# Specific Design Plan Parkside

# SDP-1302-08

SUBJECT: Specific Design Plan SDP-1302-08  
Parkside, Sections 5 and 6 Architecture

# BLYTHEWOOD HOUSE VIEWSHED EXHIBIT

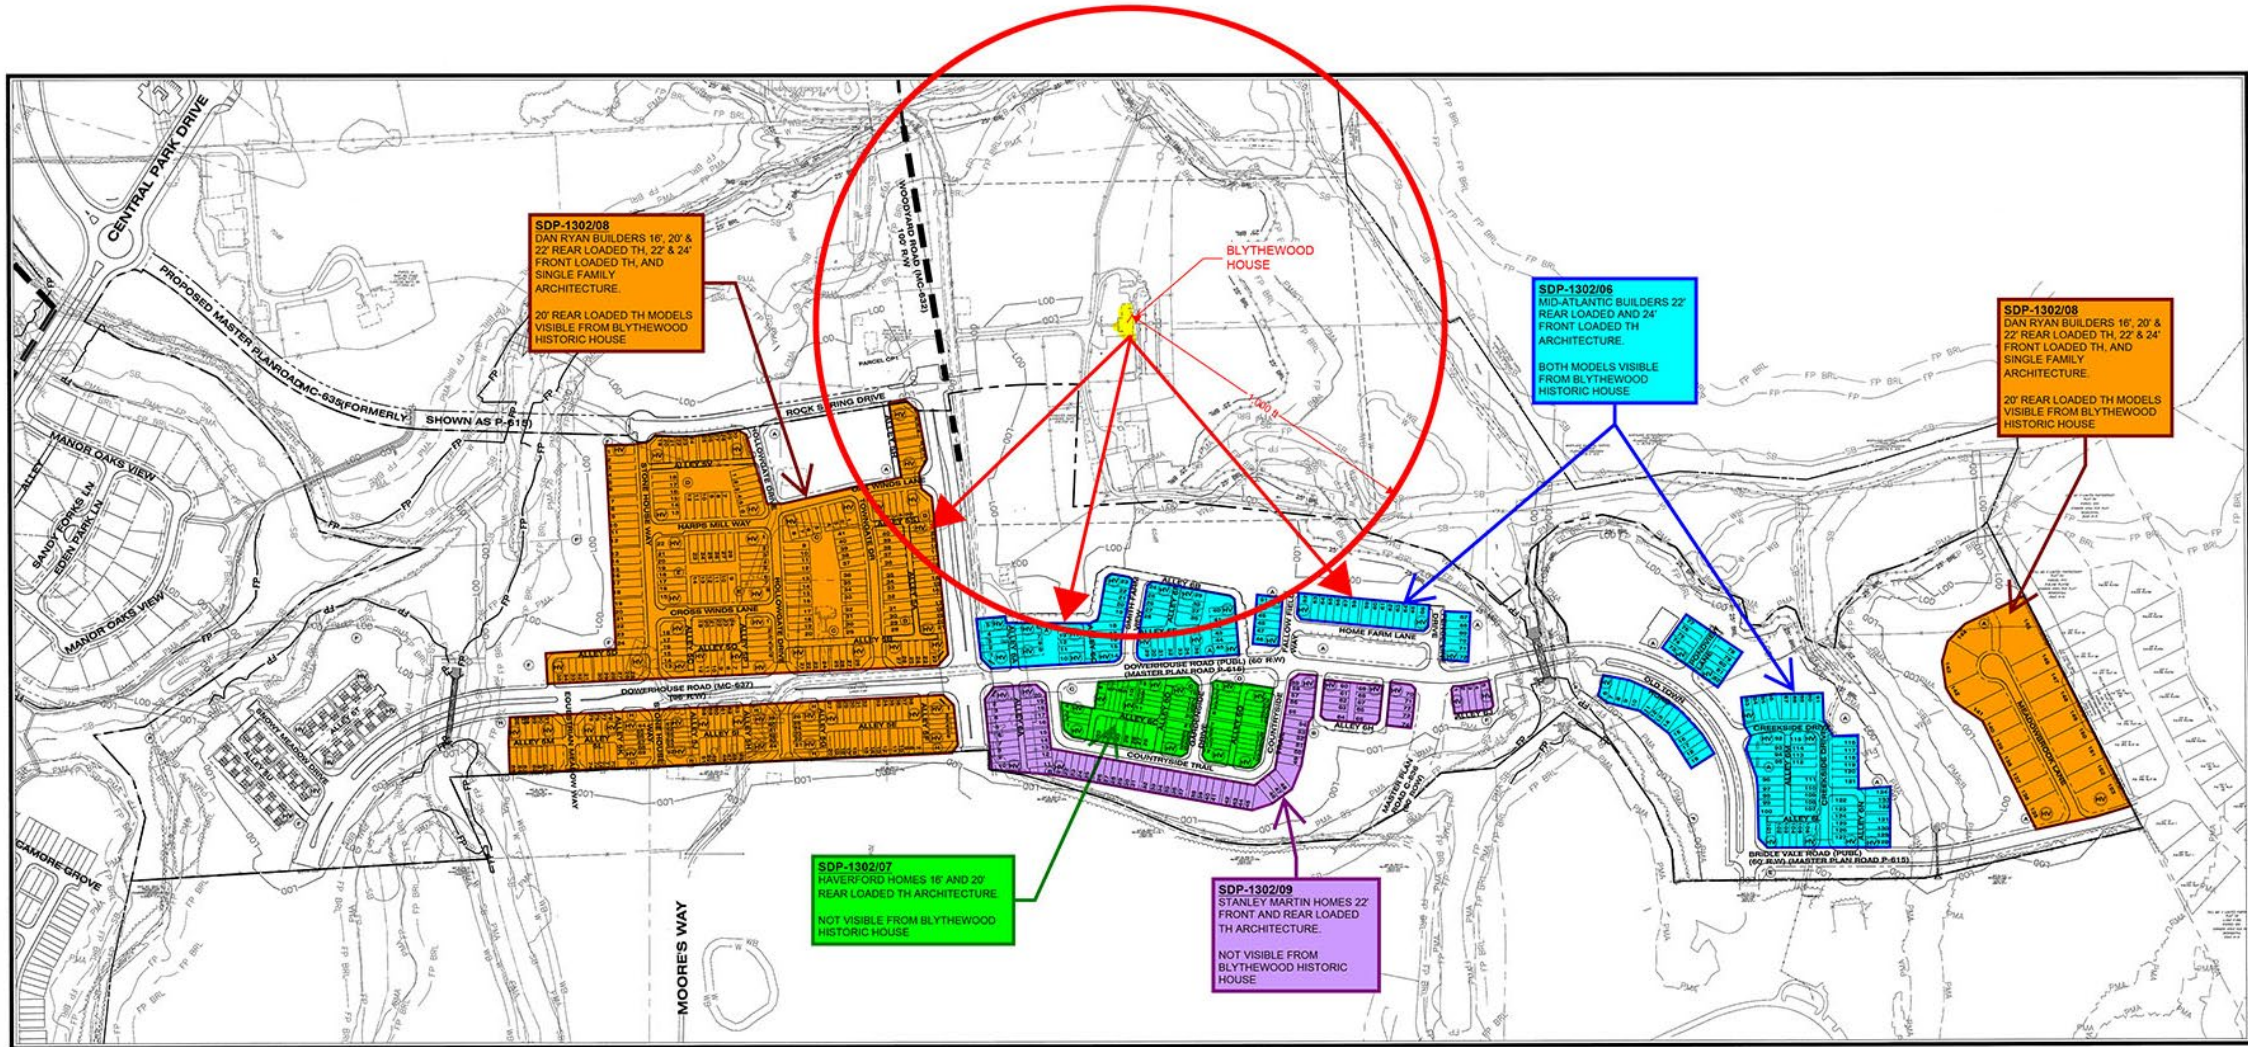
This SDP is for architecture only. The viewshed exhibit provided with this application demonstrates that the lots on which the architecture is proposed will be visible from the historic site. The architectural elevations submitted with this application show the scale, mass, proportion, and materials of the buildings and have been found acceptable.

In conclusion, the HPC indicated that the Camden II model proposed by the applicant is the only type of unit that will be visible from the Blythewood Historic Site. The fronts and sides of these dwellings provide high-quality materials and have been found acceptable.
